**TO:** Historic Landmarks Commission

**CASE NO.:** Historic Design Review Case No. HIS24-03

**APPLICATION SUMMARY:** A proposal to construct a new street-facing granite wall and rehabilitate the exterior of the 460 Bush Street SE house (c.1920).

**LOCATION:** 460 Bush St. SE

SITE PLAN

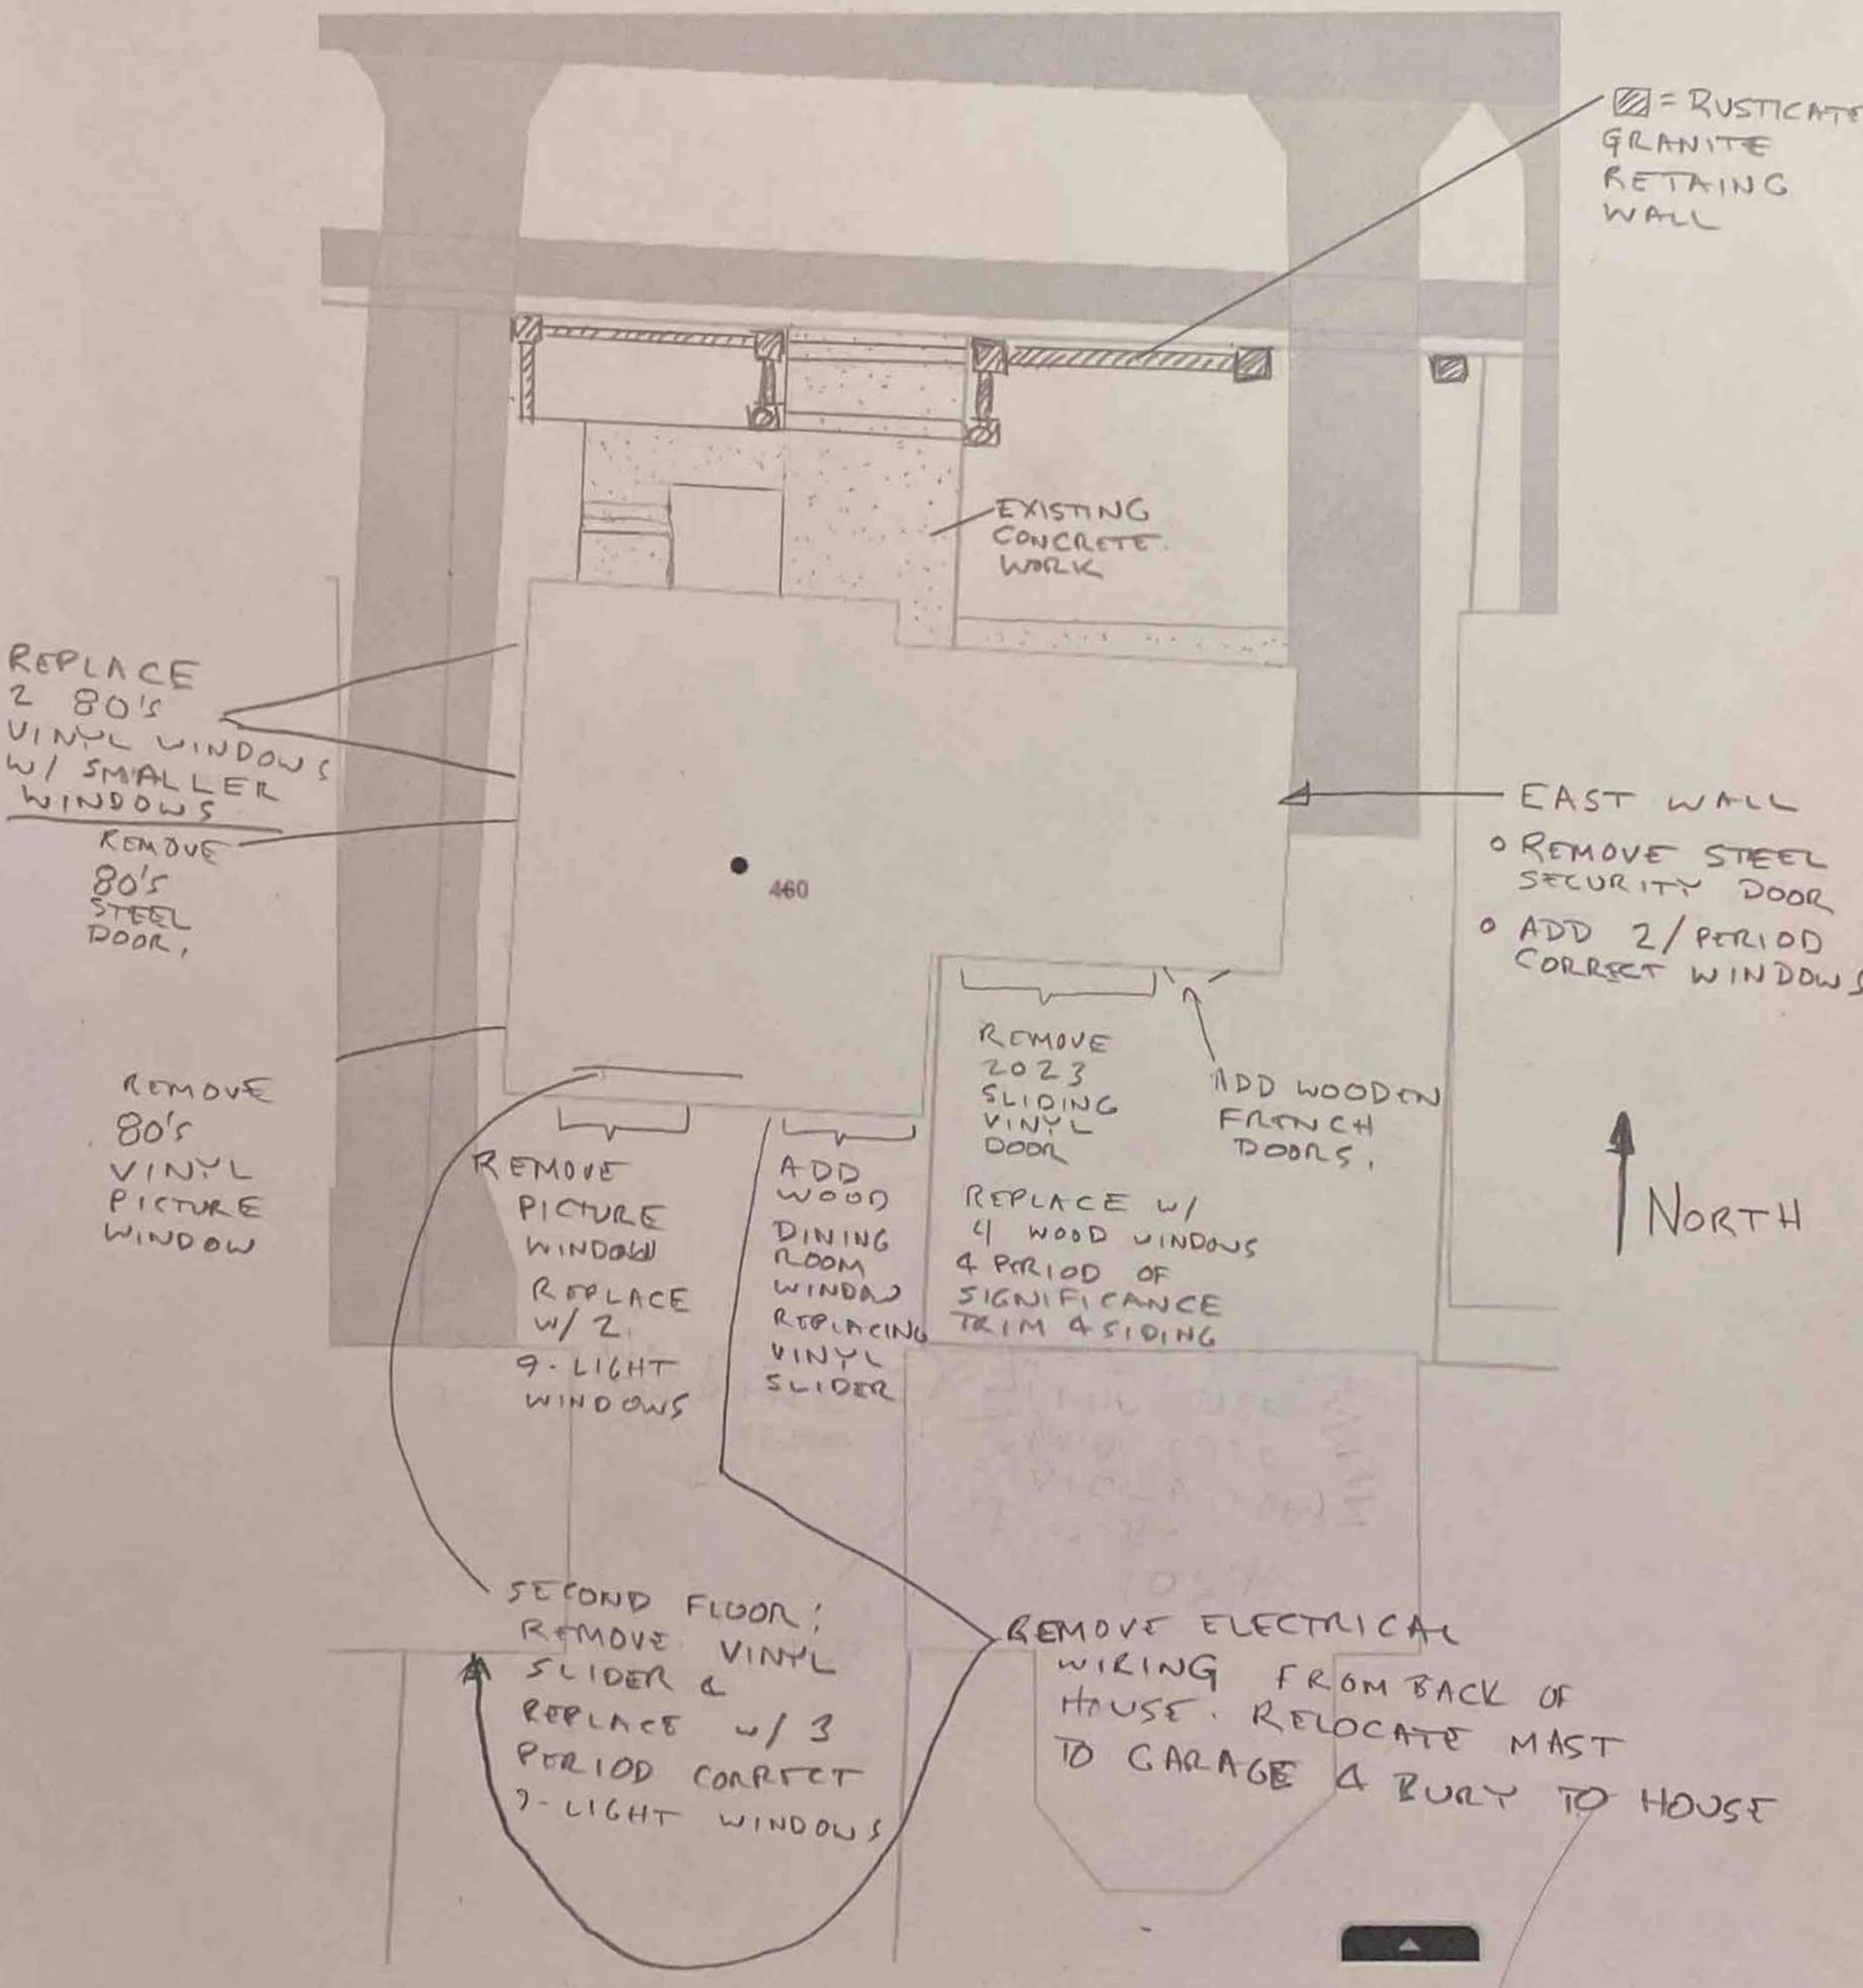
Development Services Division- Has reviewed plans (as well as under 24 101658 SF) and has cautioned that the retaining wall must not be located in the public right-of-way unless otherwise permitted through a revokable encroachment permit per SRC 76.160 which must be issued by the Public Works Department prior to any work commencing within the right of way and at time of Building Permit.

**Condition 2:** The applicant shall obtain a Public Works revokable encroachment permit per SRC 76.160 prior to the issuance of any City permits authorizing work on the property.

WALL DIMENSIONS

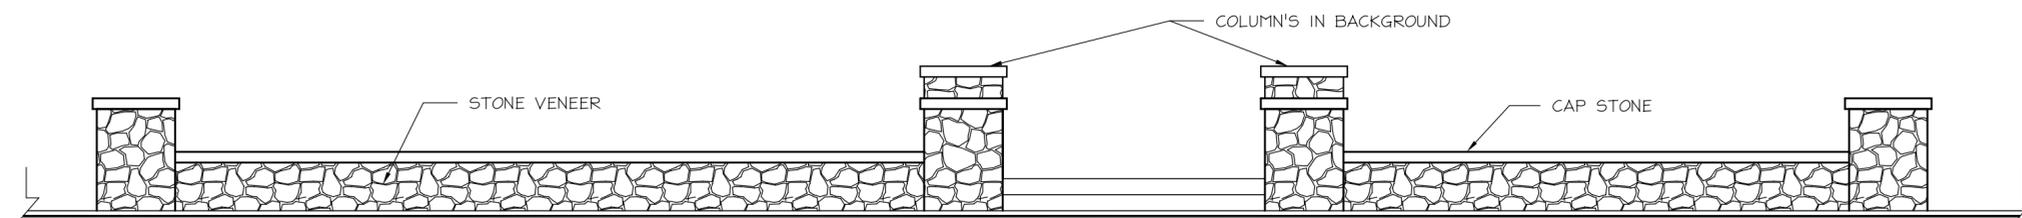
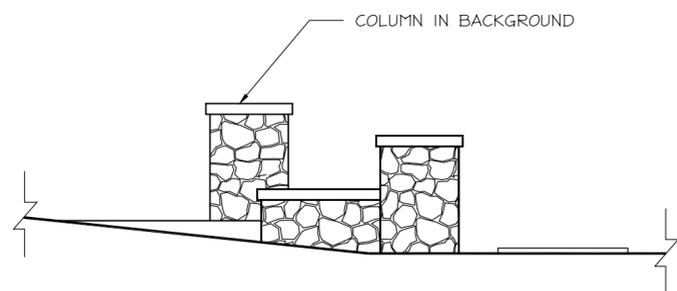
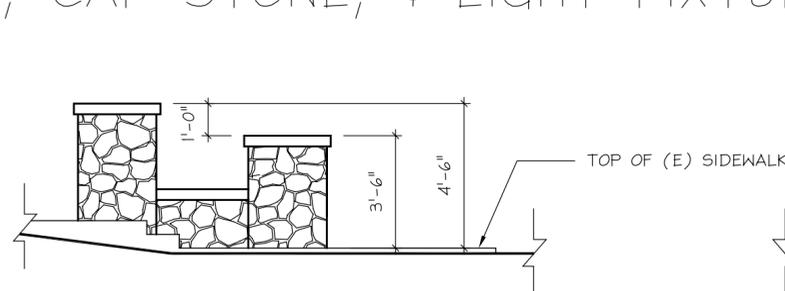
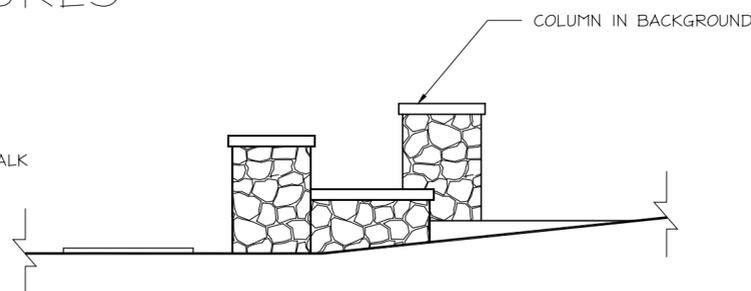
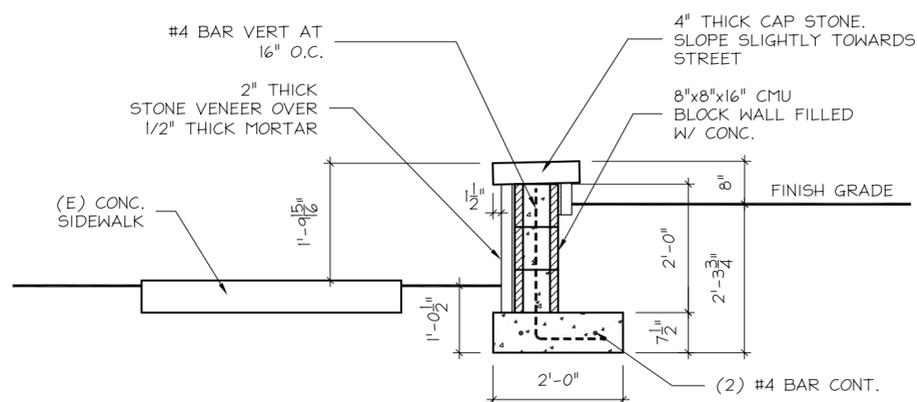
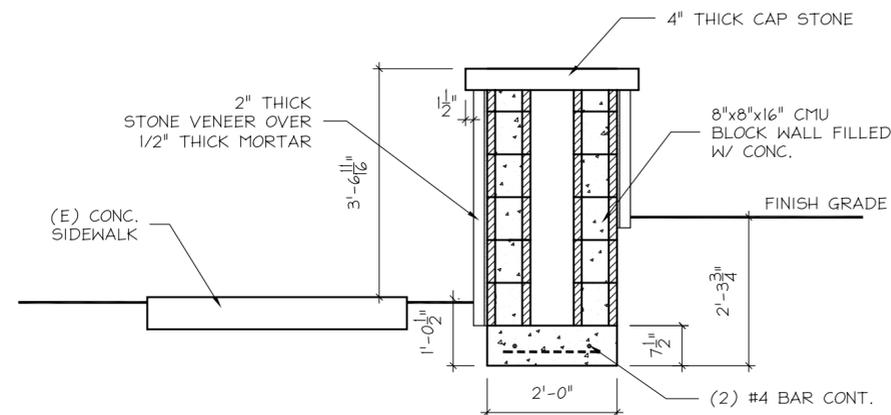
Building and Safety Division – Reviewed proposal and indicated that the stone retaining wall will require engineered design and separate permits.

Planning Division – Reviewed the proposal and commented that per SRC 800.055(a)(1)(A)(i) “Fences and walls within a front yard abutting a street shall not exceed a maximum height of four feet when located within 20 feet of the property line abutting the street; provided, however, within ten feet of the property line abutting the street any portion of the fence or wall above 30 inches in height shall be less than 25 percent opaque when viewed at any angle at a point 25 feet away from the fence or wall.” Planning noted that the columns appear to exceed 30” in height and would not comply. Therefore, the Planning Division recommended reducing the columns to a compliant height. Therefore, in order to meet the applicable requirements of the zoning code, staff recommends the HLC adopt the following Conditions of Approval:

**Condition 1:** The applicant shall modify the retaining wall design so that columns are no more than 30” in height.
